Report: Punch Lst
Function: Test, Adjust, & Balance
Date: 02/24/2025
Completed By: National TAB

Kenton County School Ops Ctr (Independence, KY)

Issue List

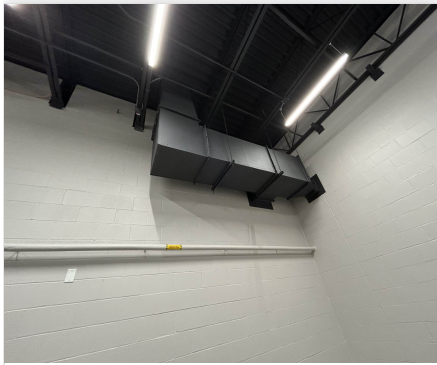
Issue Name : AirFlow station
Description : AirFlow Station not communicating with RTU oa damper. This is preventing the unit from keeping oa flow within design tolerances. Unable to start return balance until the issue is resolved.
Created By : National TAB **Assigned To :** National TAB - Nick Payne
Status : Open
Priority : Urgent **Asset Tag :**
Originated Date : 02/28/2025 - Gabe Merk - National TAB
